Access Compliance Report

Public Rights-of-Way

Intersection ID: N/A	Main Street: LABEAU_AV	Cross Street: N/A	Location: N
ADA ID: F0BFA71BB299	Ramp Type: BlendTrans2	Initial Pass/Fail: Fail	Overall Compliance: No
			Severity Score: 33.75

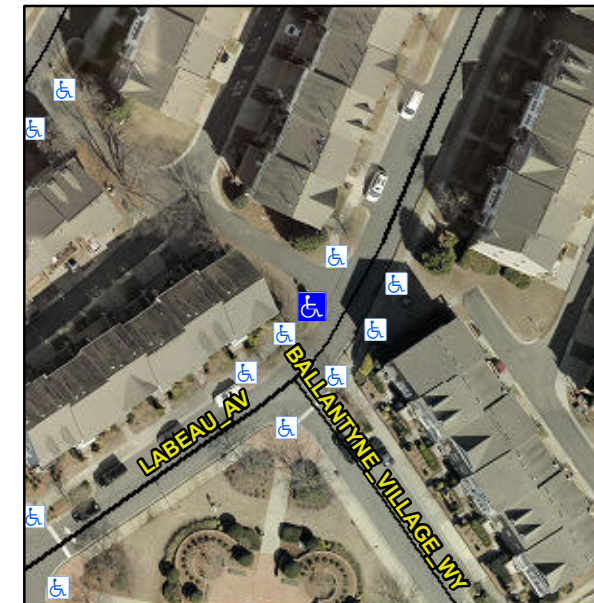
Surveyor Notes:

CURB LIP 1.0

Not Found, R304.5.1, R304.5.3

Remove & Replace Curb Ramp With Two New Directional Ramps or Equivalent.
